Alternative Readout System Architectures II

LAPPD2 Electronics Godparent Review
April 6, 2013

Responses To Review Panel

4 Stand-Alone, Single-Tile Readout Stations

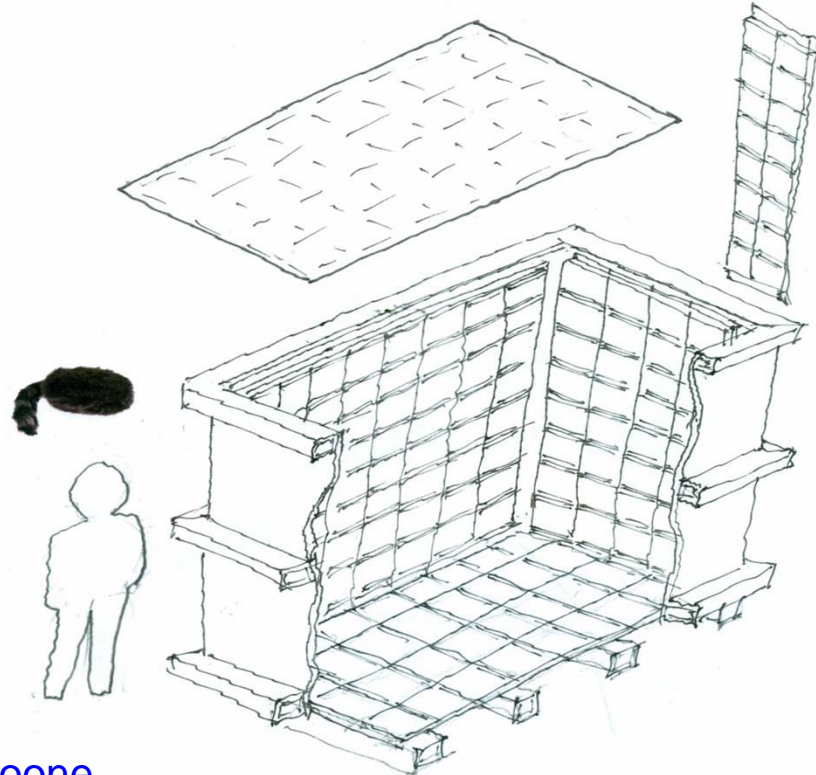
Question 1: What limited number of applications would you target as priorities in the next stage of development and why?

- 1. TOF in the LArIAT Beam**
 - a) Why: Simplest set-up that has a large impact on HEP programs**
 - b) Straight-forward interface to experiment**
 - c) Local, have collaborators in place;**
 - d) Drop in for scintillators and PMTs at higher cost and better performance**
 - e) Spec: 4 stand-alone single tile stations, 10 psec time resolution, 50KHz (needs checking)**

Use Alternative Architecture 1.

Max trigger rate:

$30 \text{ Channel} \times 10 \text{ bits} \times 24 \text{ samples} \times F_{\text{max}} = 400 \text{ Mbps}$

$F_{\text{max}} = 55 \text{ KHz.}$

Water Neutrino Detector Readout

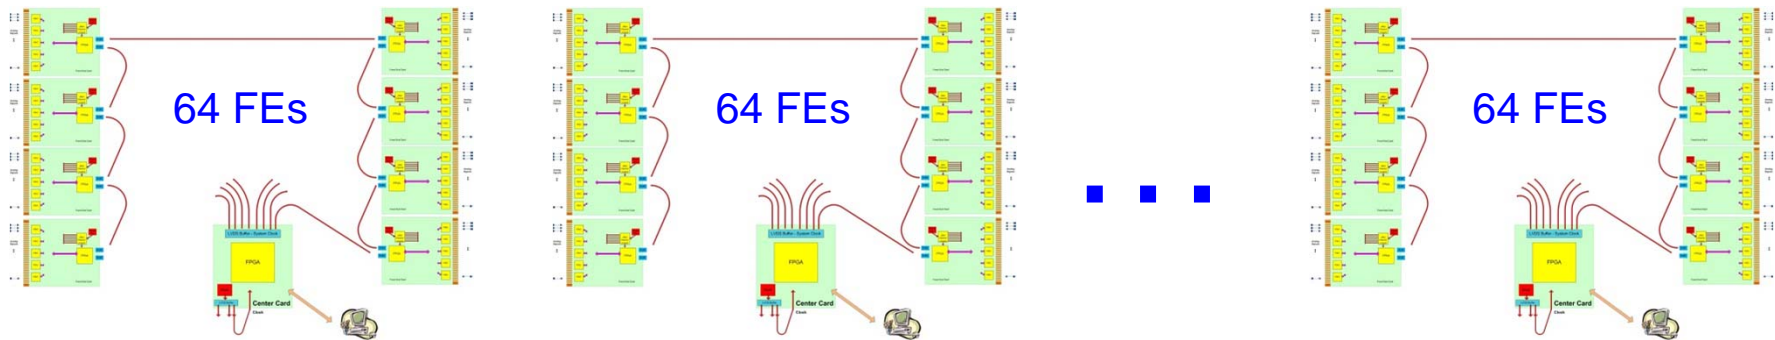
2. Small (1-4 m³) water neutrino detector prototype
- a) Why: Comparison to simulation; test of the optical TPC concept with track reconstruction
 - b) If successful, no competition
 - c) From 1 to 6 SuperModules;
 - d) Spec: Single pe resolution ~ 100psec, low rate

Requirements: 256 Front End Cards, slow Readout.

Each Central Card will read 64 Front End Cards in a daisy chain.
One of the Central Cards becomes Master and distributes the clock to all.

KOTO Pre-Converter Readout

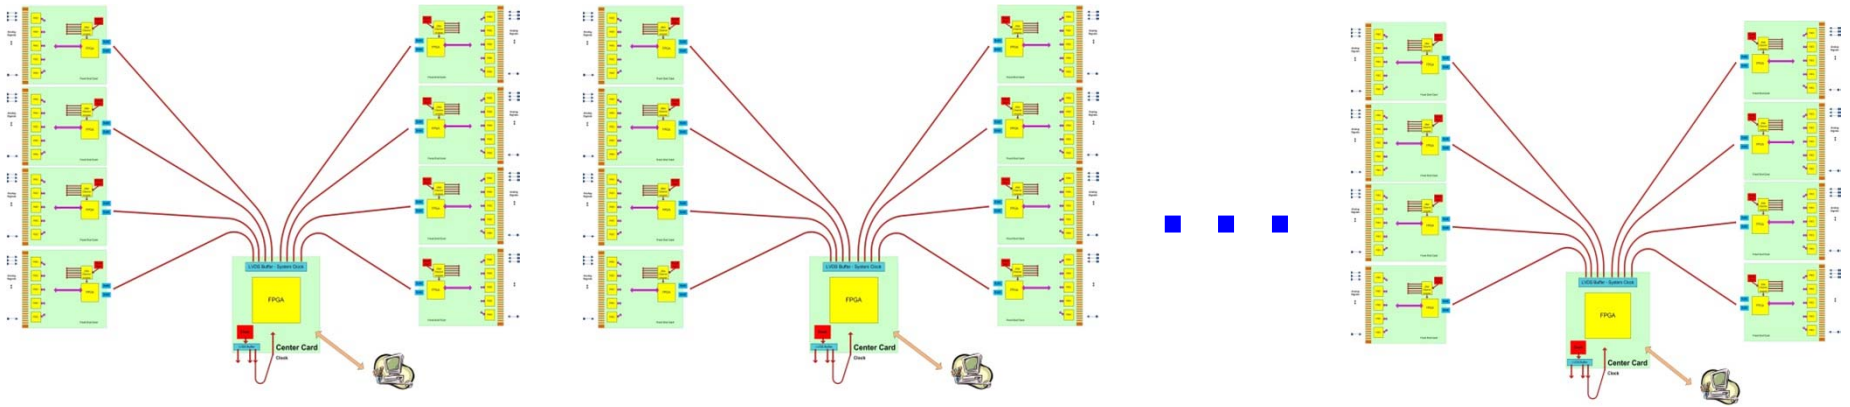
3. Pre-converter in KOTO

- a) **Why: Archetype for 3D localization and precise timing of high energy photons**
- b) **Good access to management and technical expertise in the experiment**
- c) **If successful, no competition**
- d) **1-4 SuperModules**
- e) **Spec: Timing = 1 psec; Rate = 200 kHz; Position = several mm; Trigger latency = 5 μ sec**
- f) **HEP benefit: Increased physics reach**

Each Central Card will read 8 Front End Cards in parallel.
Readout for 200KHz trigger rate with 2 LVDS SERDES lines at 720MHz for each FE Card.

One of the Central Cards becomes Master and distributes the clock to all.
Front End needs to allow for 5 us external trigger latency.
